**LEGAL ADVERTISEMENT
HISTORIC PRESERVATION BOARD
CITY OF PORTLAND
Public comments are taken at all meetings.**

**PUBLIC HEARING
1375 WESTBROOK STREET**

**WORKSHOP (3rd)
17 CARLETON STREET**

RE: August 5, 2015 Workshop to Consider Revised for India Street Historic District,
Relationship of Historic District Designation to Proposed Form-
Based Code

Existing full foundation

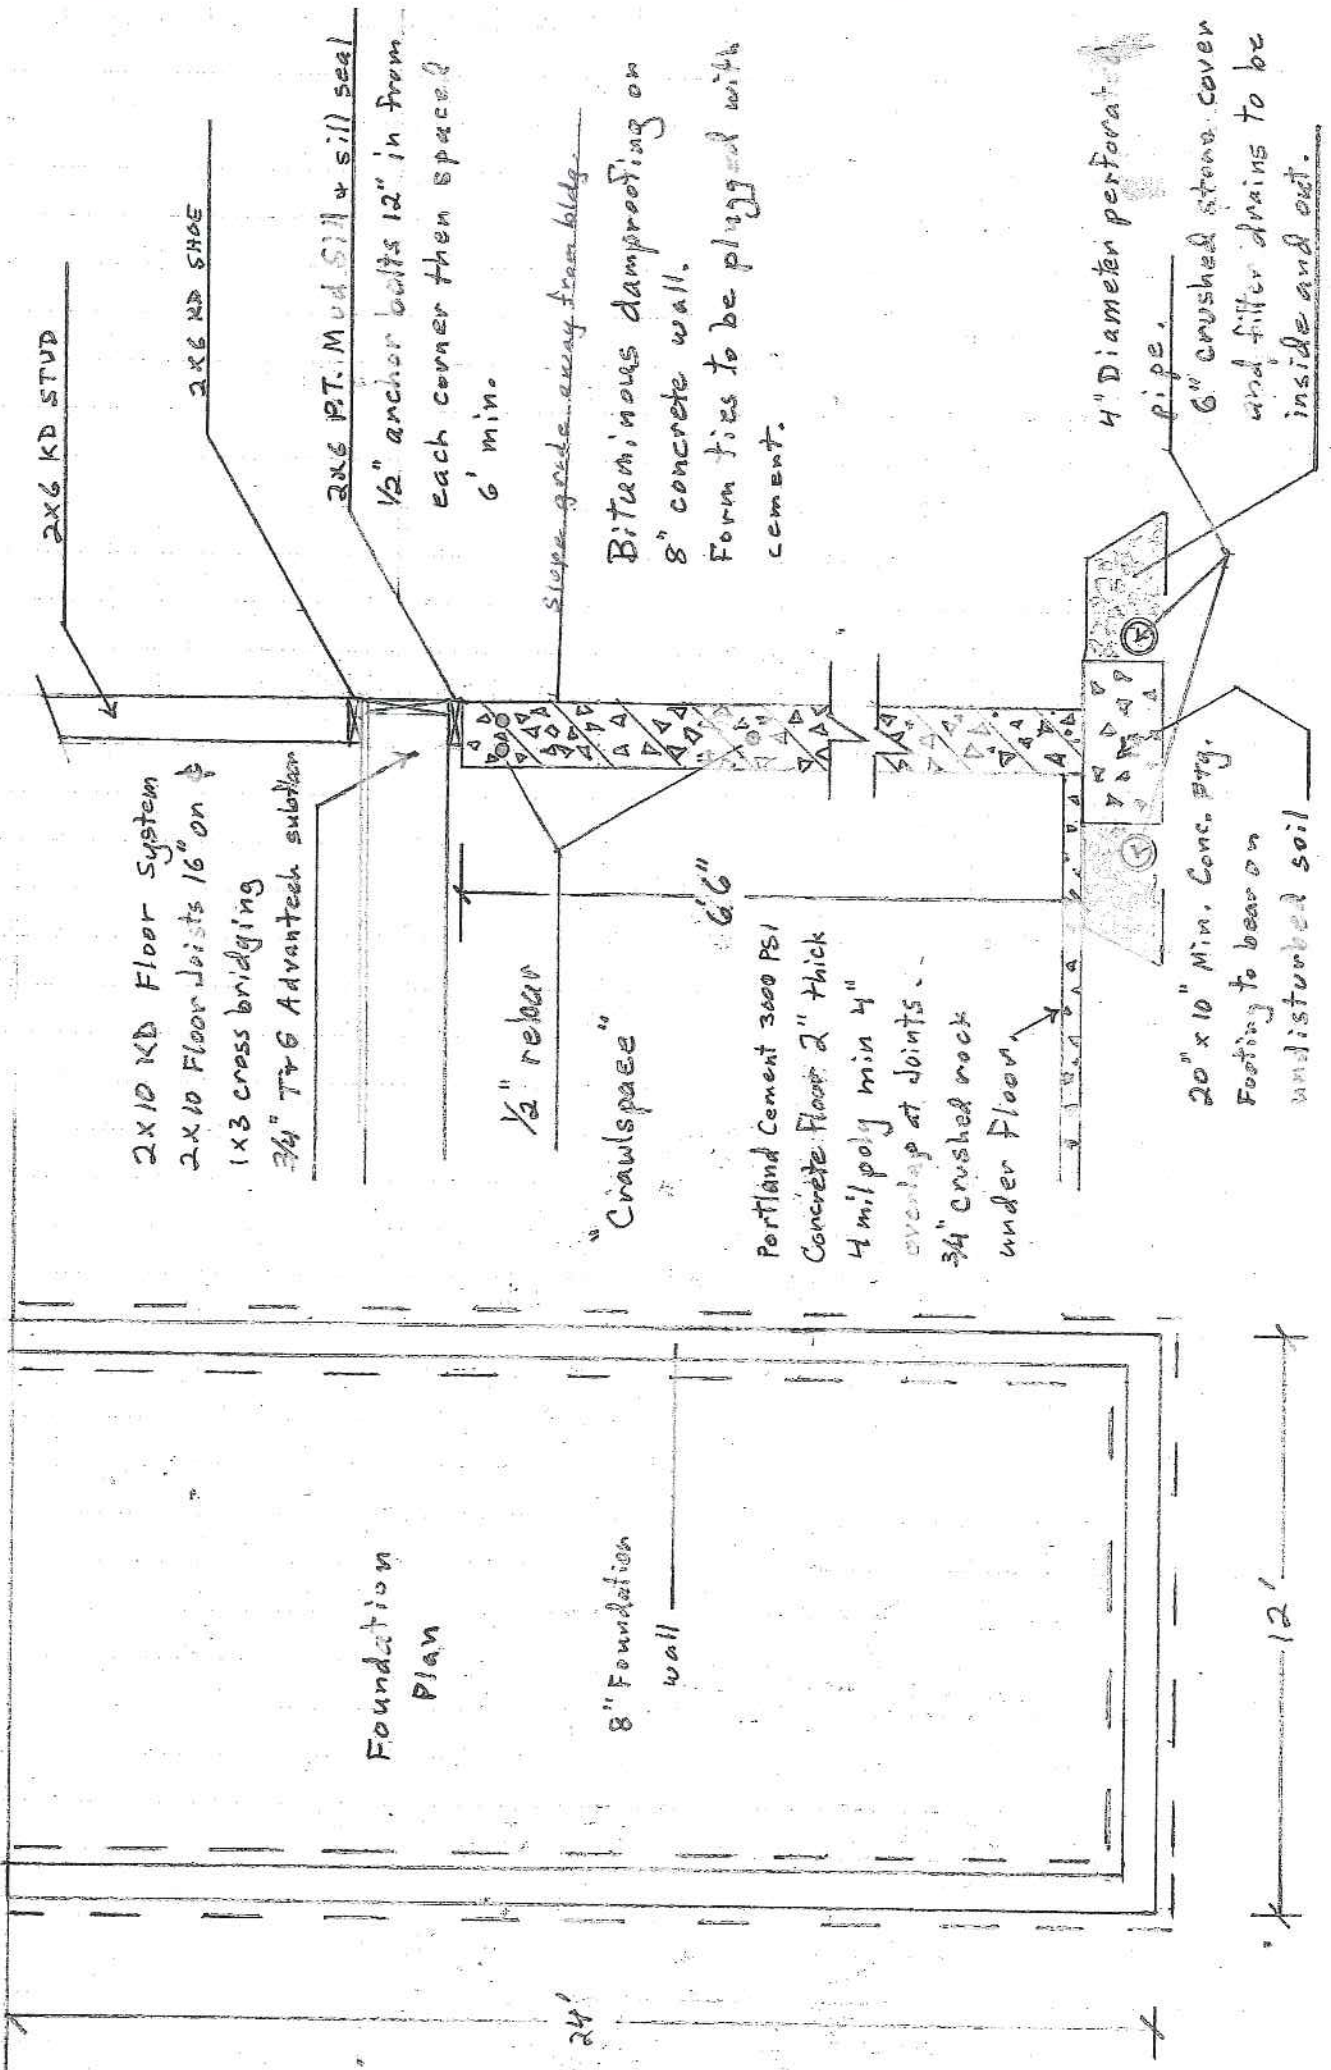
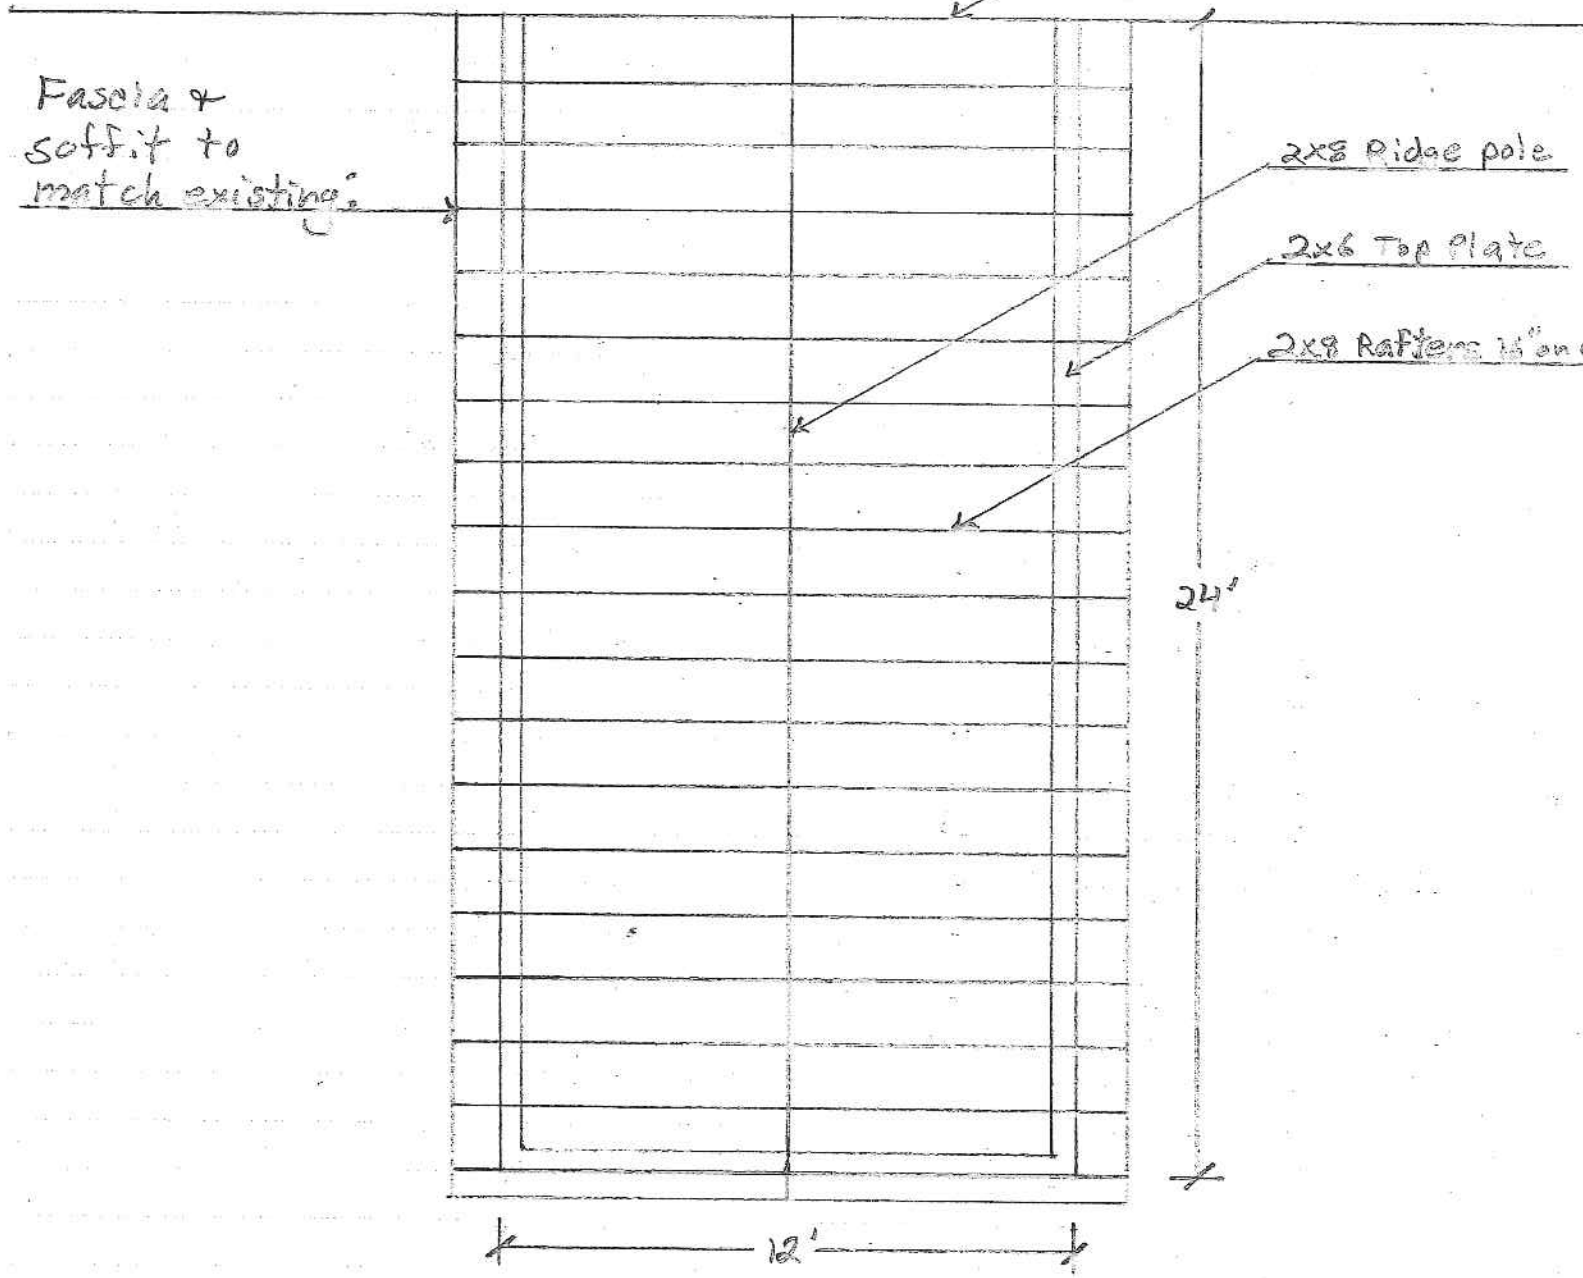
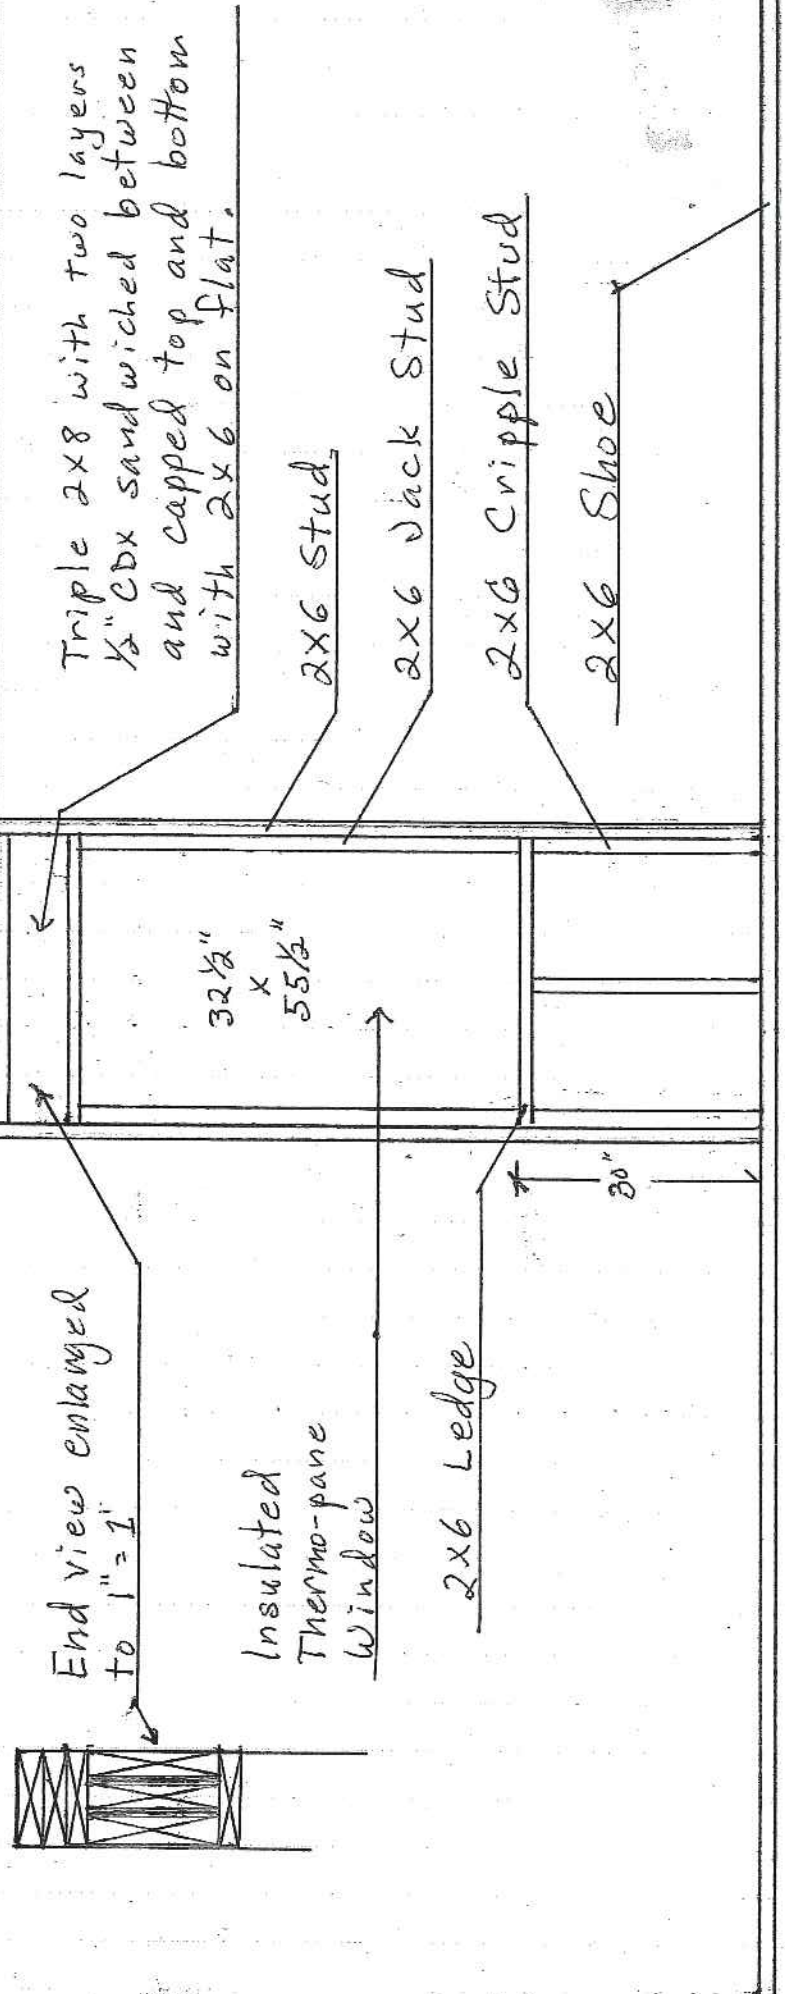
The limited visibility of the proposed addition, the non-contributing status of the property, and the location of the house at the periphery of the historic district make this project review relatively minor compared to some of the additions reviewed by the Board. Nonetheless, the review process is an opportunity to ensure that the proposed work will be compatible with the character and appearance of the original building, and not inappropriate for the Stroudwater District.

A2.1

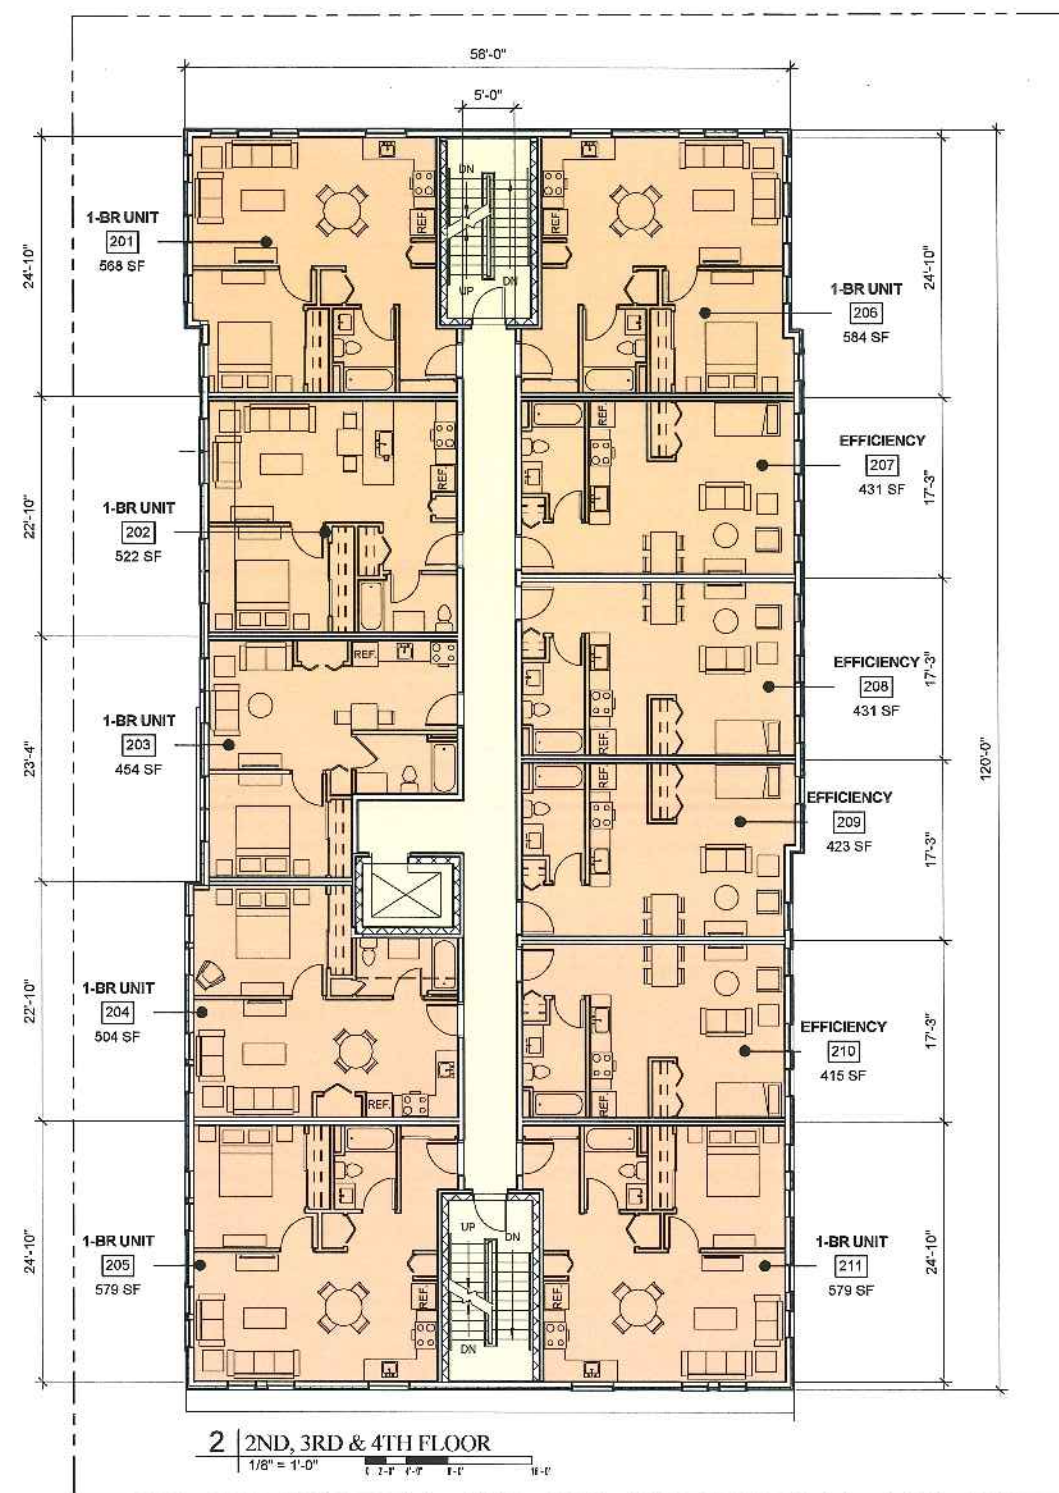
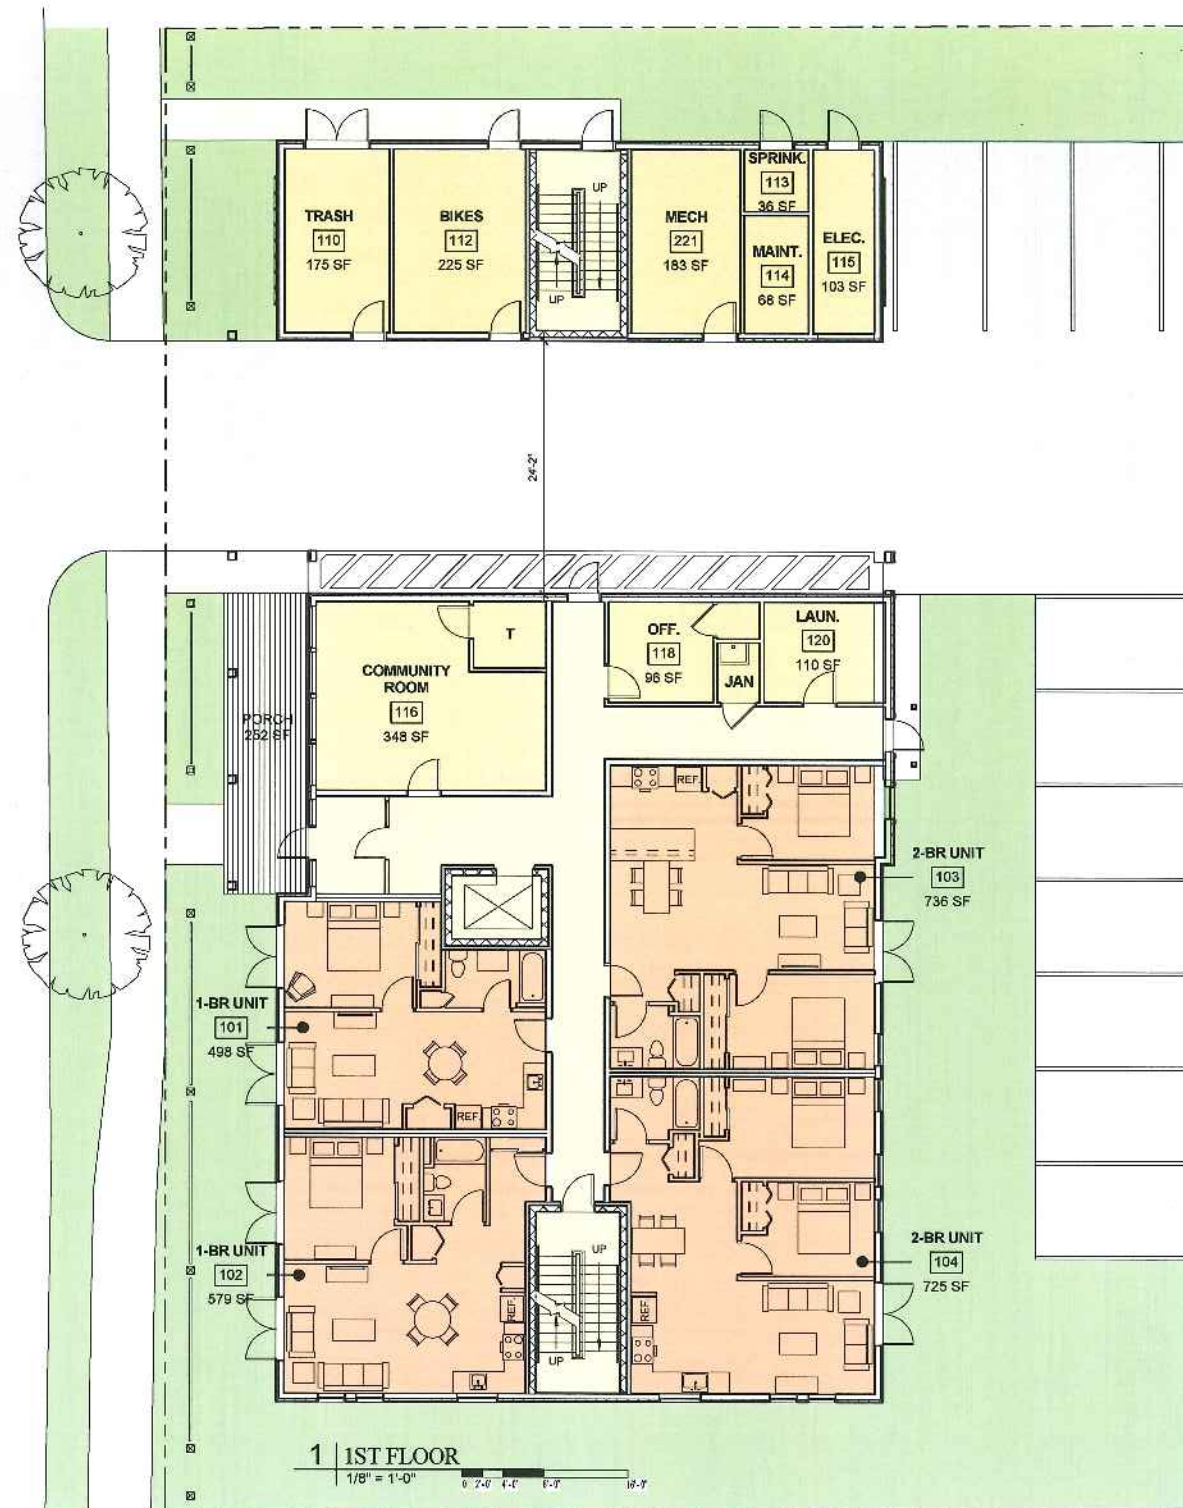
The revised proposal appears to respond successfully to a number of the concerns raised by members of the Board and public at the last workshop. For example, the project architect has taken advantage of the requirement by the Fire Department to increase the height of the vehicular passageway to provide a clear base for the building that elevates the first floor above the ground. Also, the revised entry treatment on Carleton Street successfully highlights this key feature of the building and provides a clear focus for the ground floor facade. The fenestration on this façade is now also clearly residential in character. The move toward a mansard-type roof is also successful in providing more depth and visual interest in that the windows now become projecting “dormers”.

Staff has identified a few elements of the revised design that might warrant further consideration by the Board:

- Given the required height for the vehicular passage, the overall size of this opening is now significant. To reduce the visual prominence of the opening, perhaps the lintel over the opening should be made more recessive. It may help, for example, to paint out the steel lintel to match the color of the brick. This would allow the adjacent entrance porch to clearly dominate and downplay the opening. The treatment of the interior walls of this passageway will also be important, especially since one of the handicap entrances to the building will be within this passageway.

- Regarding the location of the vehicular passageway, staff is curious as to whether consideration was given to moving the vehicular passage to the north end of the building. By separating the passageway from the main entrance, further prominence would be given to the entrance. Perhaps this is not feasible from a programmatic or floor plan perspective, but perhaps worth raising.

- The proposed projection of the mansard-roofed section at the south end of the building seems a bit curious, especially when the other mansard section at the opposite end is flush with the center section. This might warrant further discussion.

- The treatment of the at-grade rear entrance to the building might benefit from the addition of simple sidelights. This would give the entry a bit more prominence and correspond to the width of the canopy in front of it.

- As regards the clapboard siding on the rear of the building, although some members of the public expressed concern about this material choice, in staff's view the material is consistent with the material palette of the neighborhood and therefore not incompatible. While this face of the building will indeed be visible from the rear of other buildings, it is the rear façade where buildings often feature a less formal design and material palette.

- In discussions with Keith Gautreau he expressed that he will need fire truck access to the rear parking lot. Therefore he has requested that we give him a clear 13 feet 9 inches in the passageway under the building. To accommodate this requirement we have put the building on a base of approximately 3 feet. This does give us the feature of having the first floor raised as has been discussed to be more in keeping with the neighboring buildings. We have modified our other building entries to allow our required ADA access. Please see our revised elevations

- 4th floor roof changed to mansard
- Fenestration on Carlton street elevation revised to a similar pattern and proportion as shown on rear elevation
- Water table incorporated at base of clapboard

- 4th floor windows redesigned in mansard and details added
- Front porch revised, roof raised, front door and sidelights more traditional, columns fattened, glass wall behind redesigned as traditional windows

- Patio doors eliminated at first floor
- Bay windows deleted
- Window headers proud 1 inch
- Central ERV system to be incorporated to eliminate cooking range and bathroom vents

- Roof over car passageway eliminated
- Lattice work eliminated
